PROPERTY ADDRESS: 4253 Linthicum Road

RE: **4253 Linthicum Road, BAT Site Plan and LPD design: comment**

RE: **4253 Linthicum Road, BAT Site Plan and LPD design: comment**

PERCOLATION TEST RESULTS, A-526195		
SITE PLAN FOR BAT INSTALLATION 4253 LINTICUM ROAD LOT 2 LEVINE PROPERTY		
PLAT MDR 20574 TAX MAP 22 GRID 19 PARCEL 217 ZONING: RR-DEO 5th ELECTION DISTRICT HOWARD COUNTY, MARYLAND		
 Linda D. Alexander Qualified Professional		 CLSI www.clsi-civileng.com 439 East Main Street Westminster, MD 21157-5539 (410) 848-1790 FAX (410) 848-1791
Date	Revisions	Drawn By: BM
11/13/13	REV'D TRENCH DESIGN AND LAYOUT PER HC COMMENTS	Designed By: LDA
		Reviewed By: LDA
		Date: 3/24/14
		Scale: 1" = 40'
		Job No.: 2006208
		Sheet: 1 OF 2

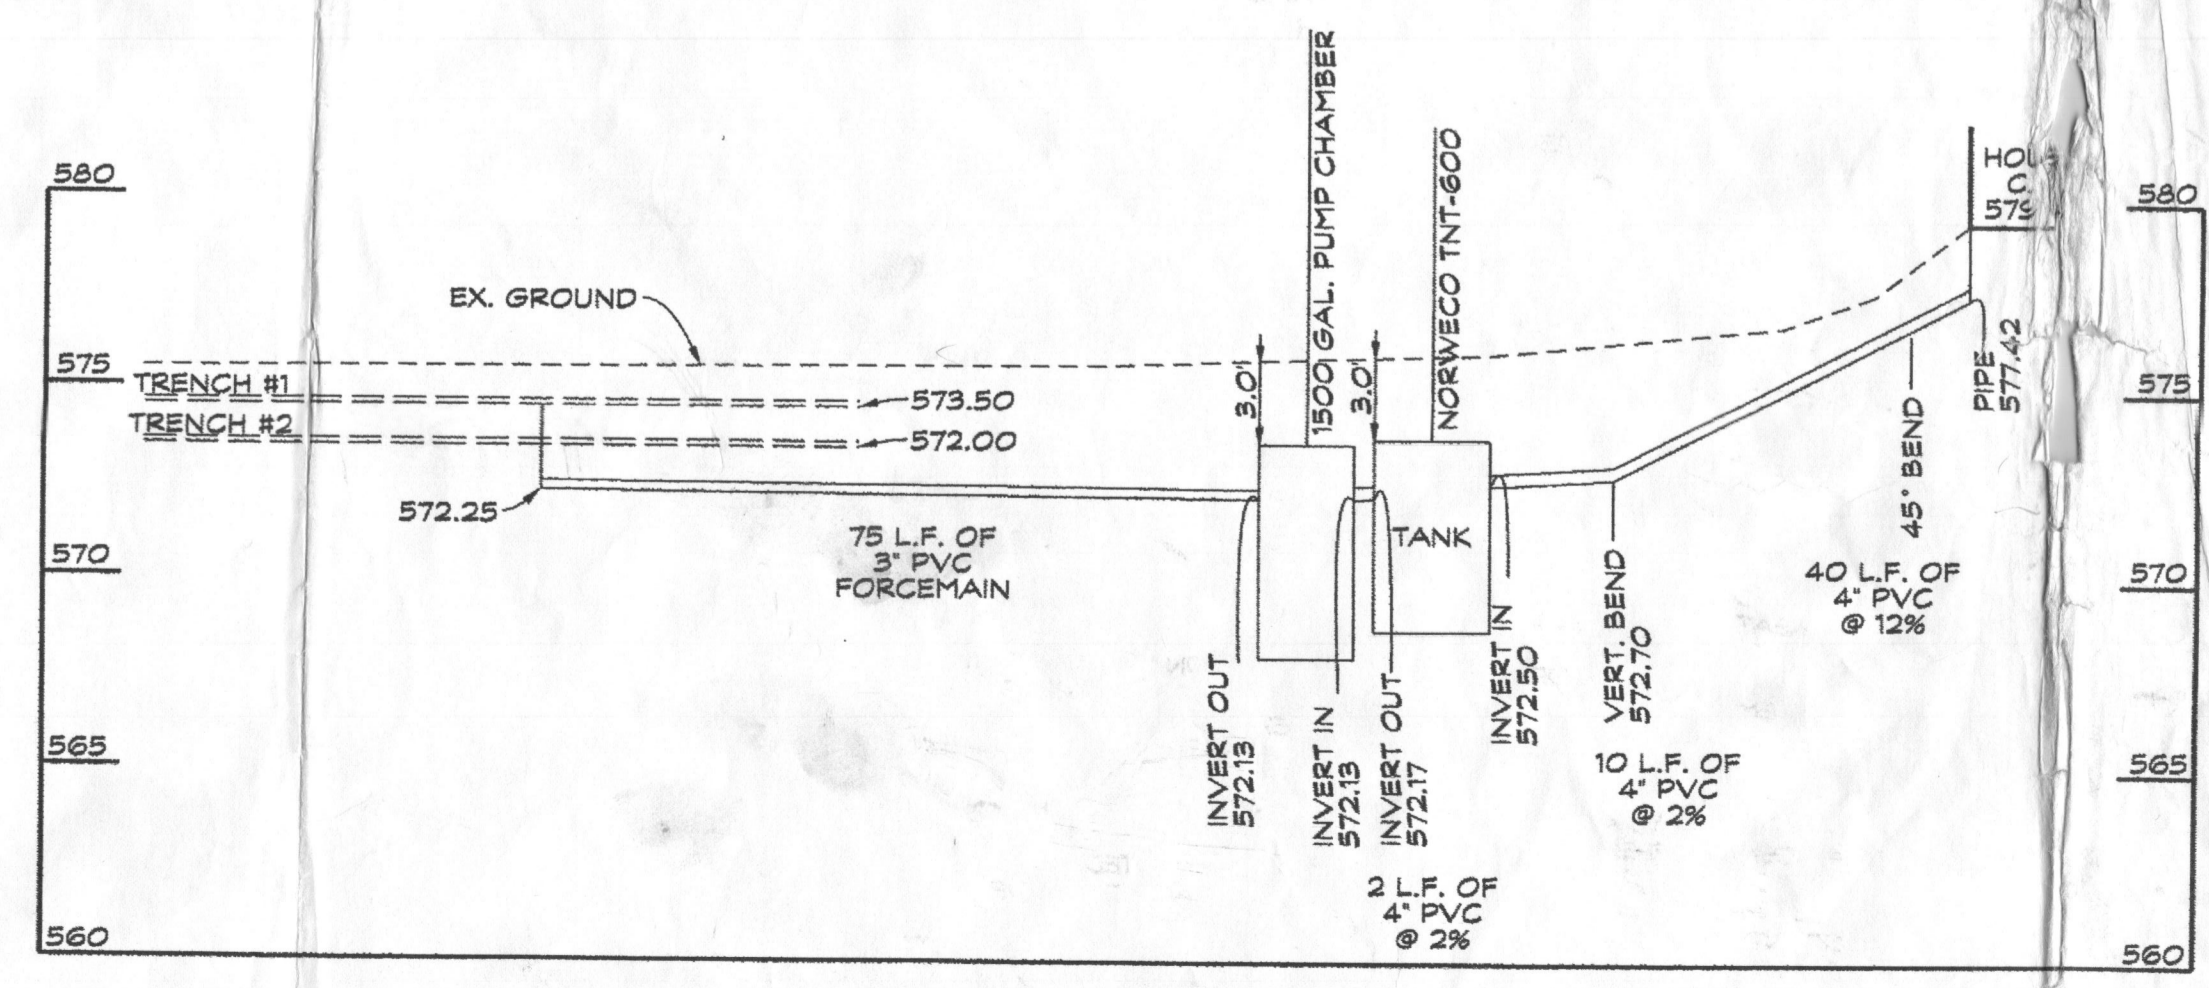
1. The BAT unit location is not approvable. Propose the Bat unit in the near corner of the SDA and illustrate the 1500-gallon pump chamber 1-2 feet after the BAT unit.

1. The BAT unit location is not approvable.
 - The setback to the residence foundation is 20 feet and
 - the setback to the level spreader is 25 feet.
 - BAT unit and Pump Chamber location near, or in, SDA is OK.

NORWECO TNT-600 DETAIL
NOT TO SCALE

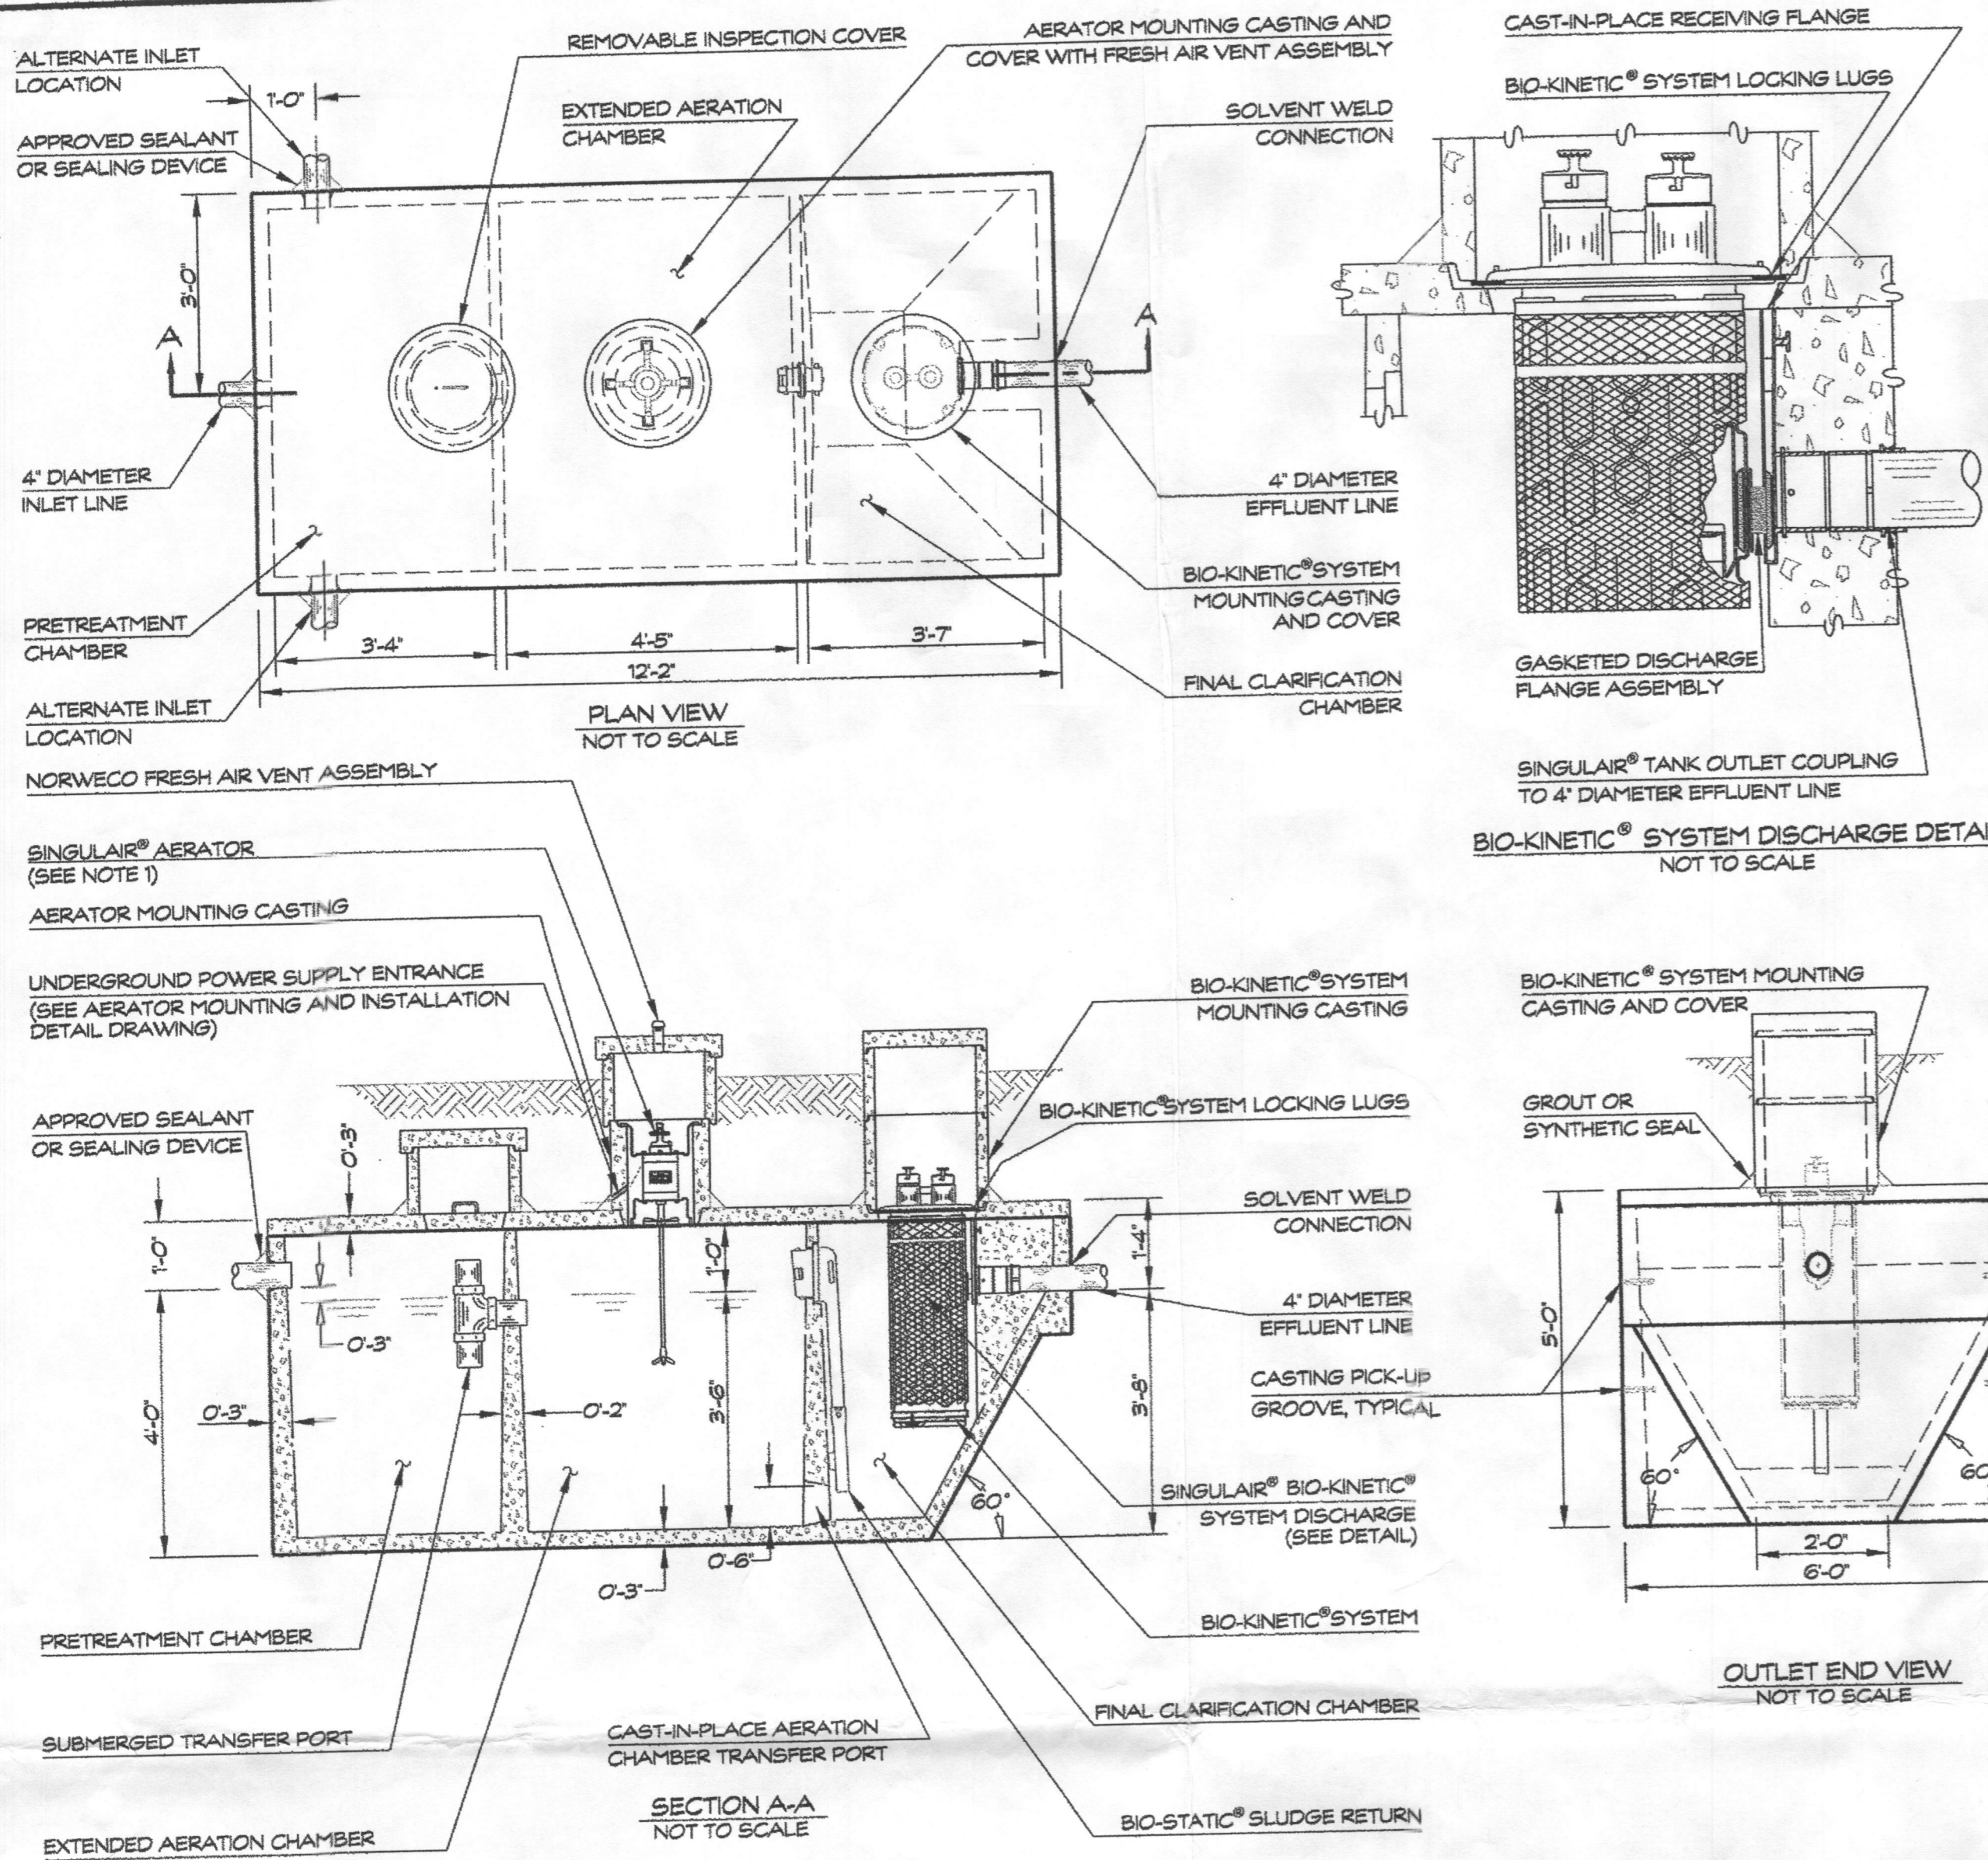
7. In the detail titled Section A-A, insert the nomenclatures for the Make and Model of the system being represented in the profile.

TRENCHES DETAIL
NOT TO SCALE

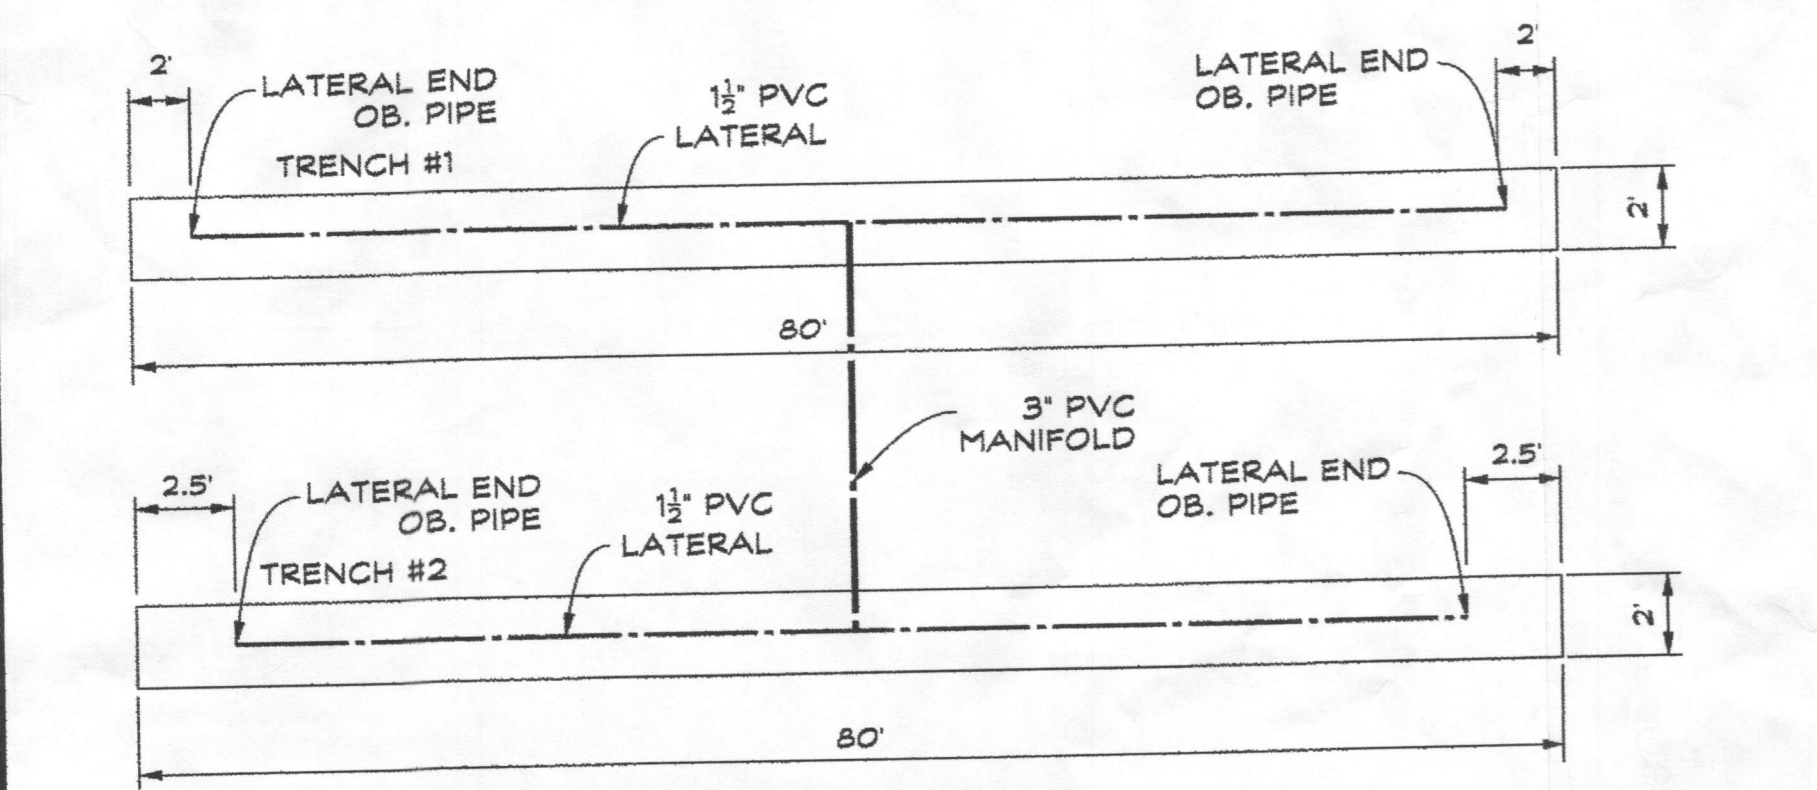
3. Edit the Trench Detail as follows:
 - Label Trench 1 with a total length of 76 feet
 - Label the ½ interval at each end of Trench 1 as 2 feet
 - Label Trench 2 with a total length of 76.5 feet

LATERAL DETAIL
NOT TO SCALE

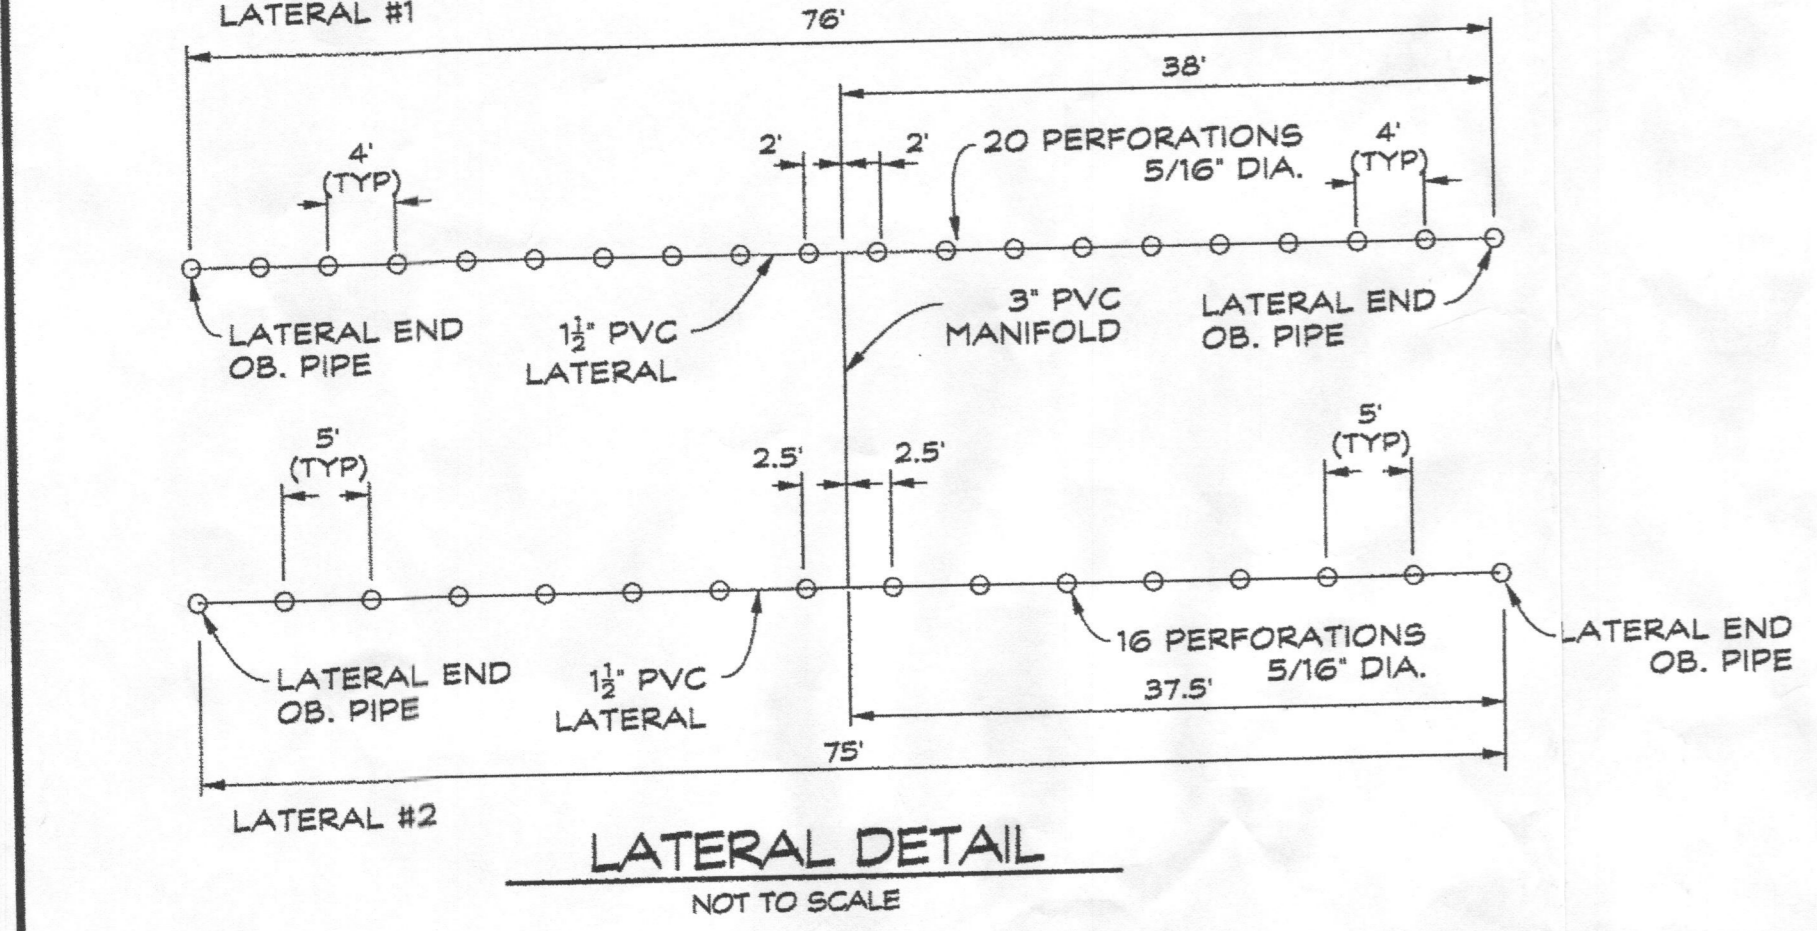
- Label the ½ interval at each end of Trench 2 as 2.25 feet.
4. As indicated in #3 above, edit the Lateral Detail as follows,
 - For Trench 1 there are 18 (5/16") perforations, at 4-foot intervals, and

- For Trench 2 there are 16 (5/16") perforations, at 4.5-foot intervals.
 - Label the total length of Lateral 1 as 72 feet, and
 - Label the total length of Lateral 2 as 72 feet

2. The Trench Detail is correct, though it may be effected by correction of the Lateral Detail. The half-perforation space inserted between the last two perforations in each lateral is incorrect.
